Proposal for a Modification of the Bumper Test Area for Lower and Upper Legform to Bumper Tests

2nd Meeting of Informal Group GTR9 Phase 2
Osaka, March 28th and 29th 2012

Bundesanstalt für Straßenwesen

Proposal for GTR9 amendment

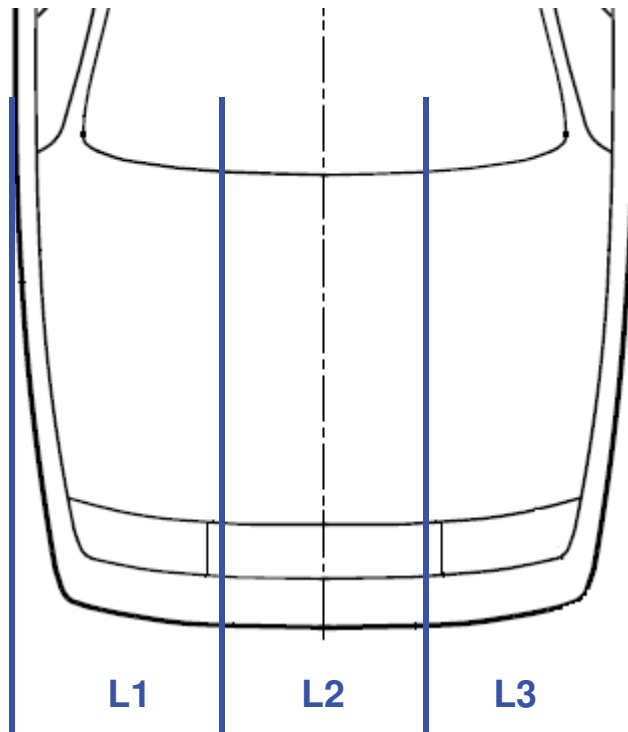
- **Test area: Whole width of the vehicle**
i.e. nominal width of the vehicle without mirrors
(from technical datasheet)
- **Test area divided into three equal parts (for EU Regulation)**

Bumper test area according to BAST proposal

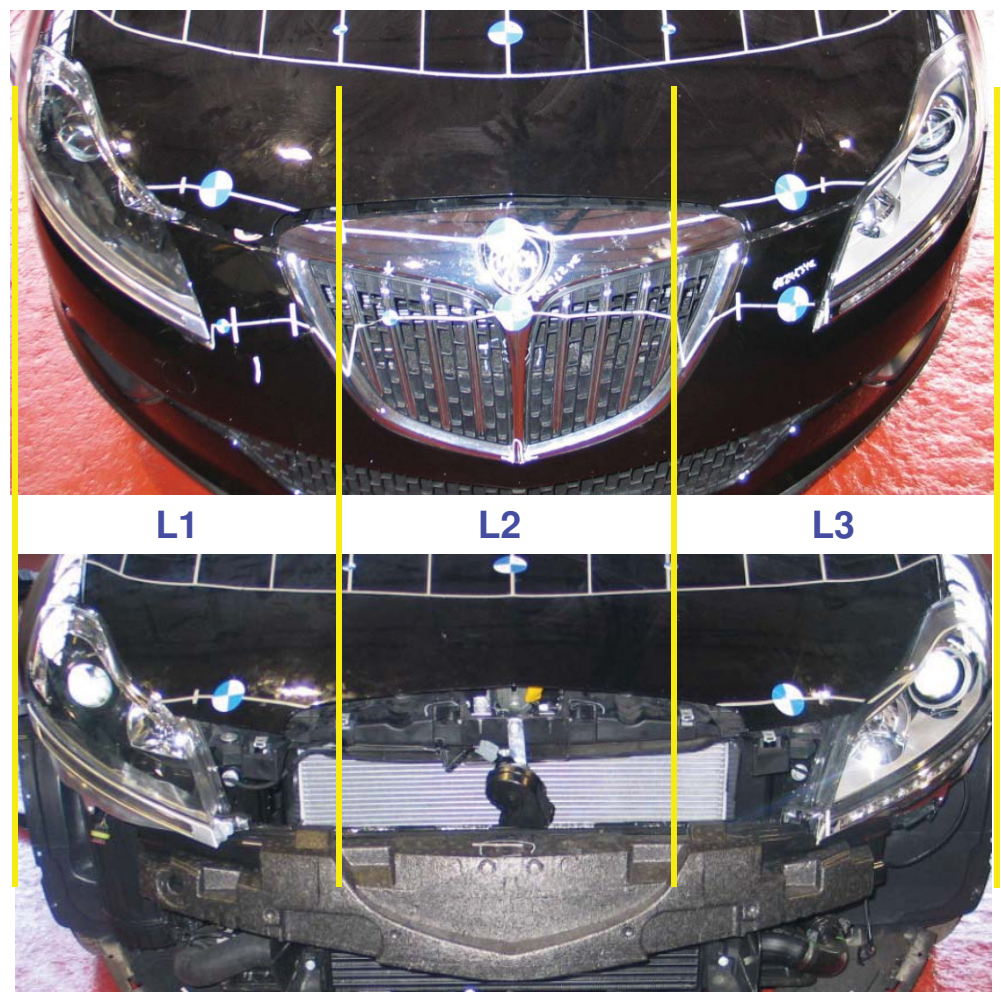
Proposal for GTR9 amendment
